UNIVERSITY OF NEW MEXICO AGN-201M REACTOR

AMENDMENT TO RENEWED FACILITY OPERATING LICENSE

Amendment No. 5
License No. R-102

ATTACHMENT TO LICENSE AMENDMENT NO. 5
RENEWED FACILITY OPERATING LICENSE NO. R-102
DOCKET NO. 50-252

Figure 1

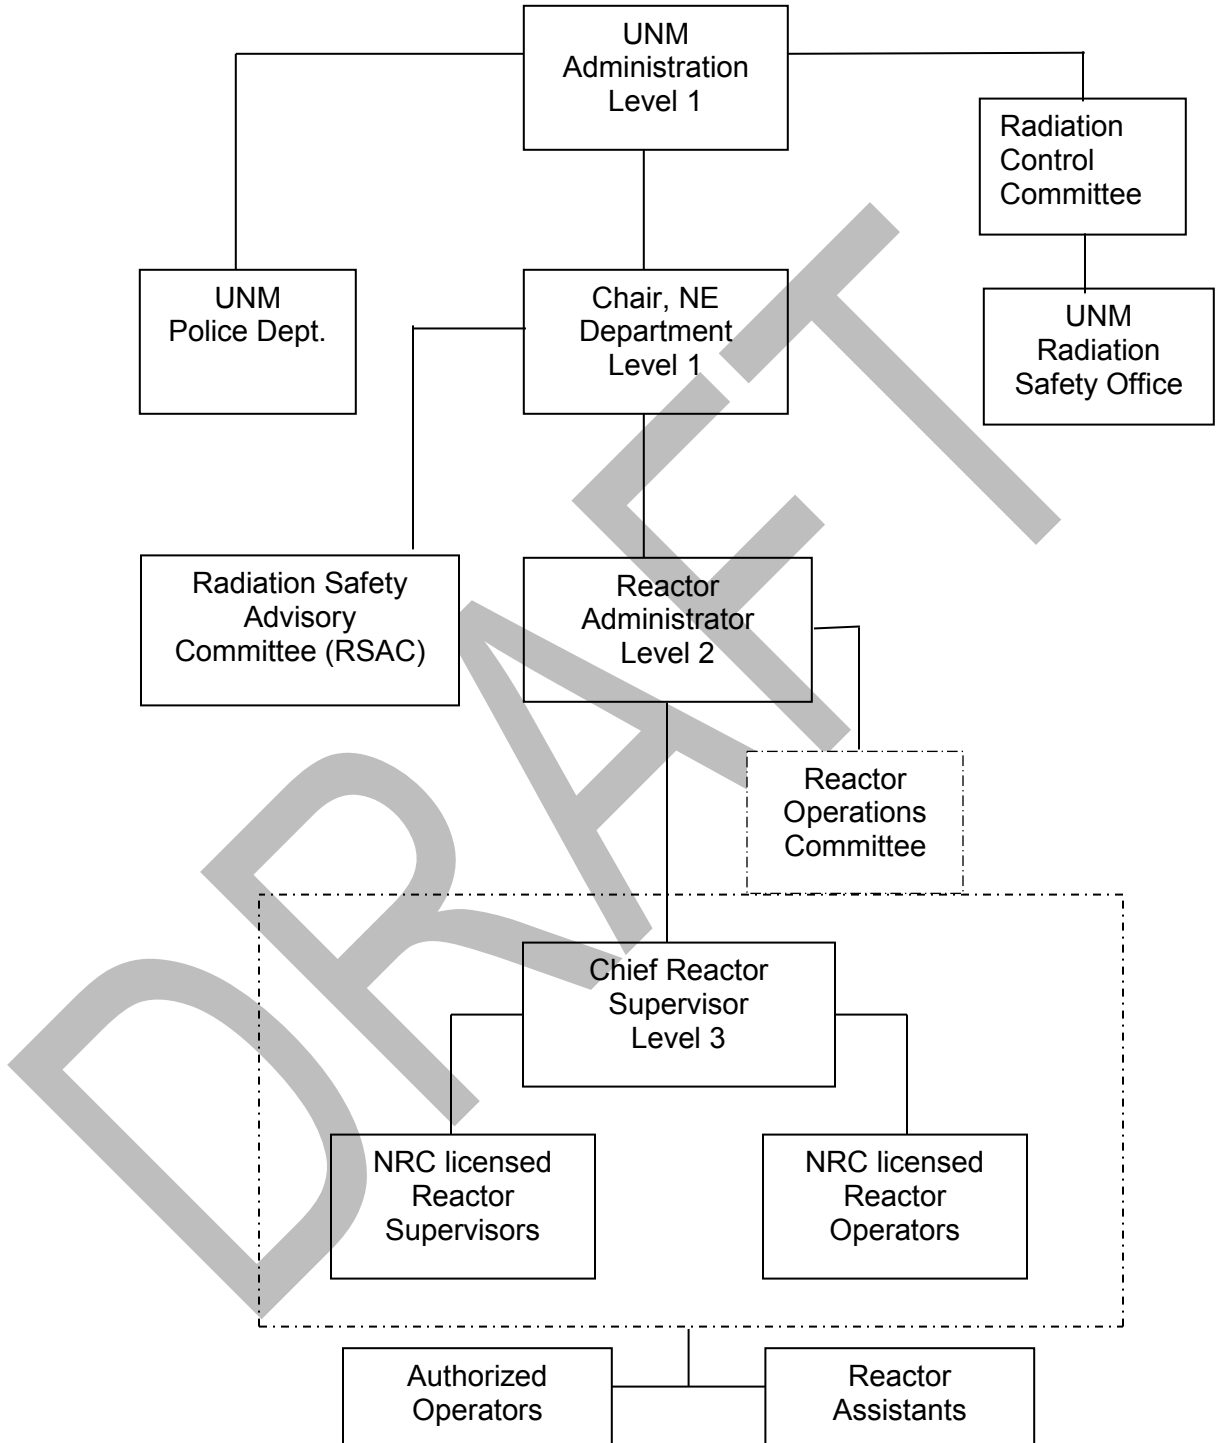
The current administrative organization for control of the reactor facility and its operation is as set forth in Figure 1. Levels 1, 2, and 3 refer to administrative levels for which changes in staffing must be communicated to the Nuclear Regulatory Commission as set forth in 6.9.3. The authorities and responsibilities set forth below are designed to comply with the intent and requirements for administrative controls of the reactor facility as set forth by the Nuclear Regulatory Commission.
